TECH TIPS
#1220

COACH MODEL :	T2140, T2145 and C2045 with DD13 Engines
DATE :	11/09/2012
SUBJECT :	Auxiliary Air Leak With Detroit Diesel Engine Code 4335/1

Viewed through the Turbo access panel left side of coach.

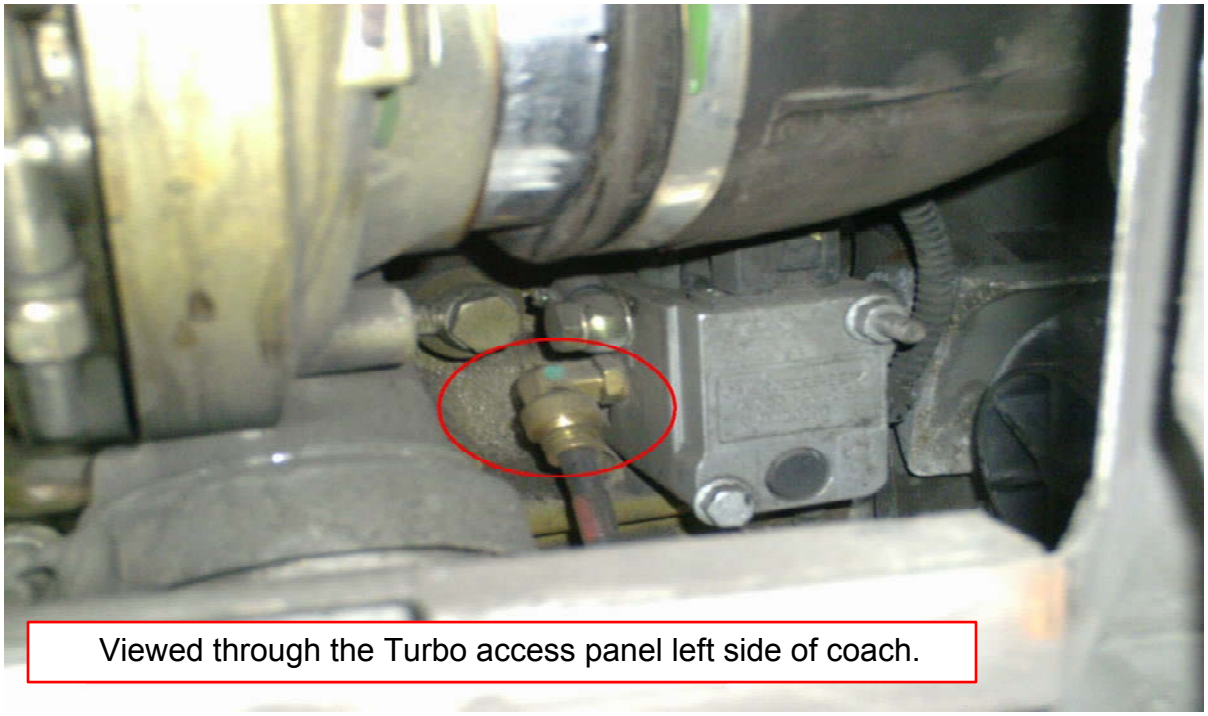
Detroit Diesel has identified a potential air leak at the turbo waste gate air fitting and have updated it with a new part and part number.

If the fitting is leaking, some or all of the following symptoms might be present.

- Engine warning light
- Low auxiliary air pressure
- Code 4335/1 (SPN/FMI) Diesel Exhaust Fluid (DEF) air pressure not detected
- Audible air leak

The new part number that is supplied by Detroit Diesel is: A0019977570
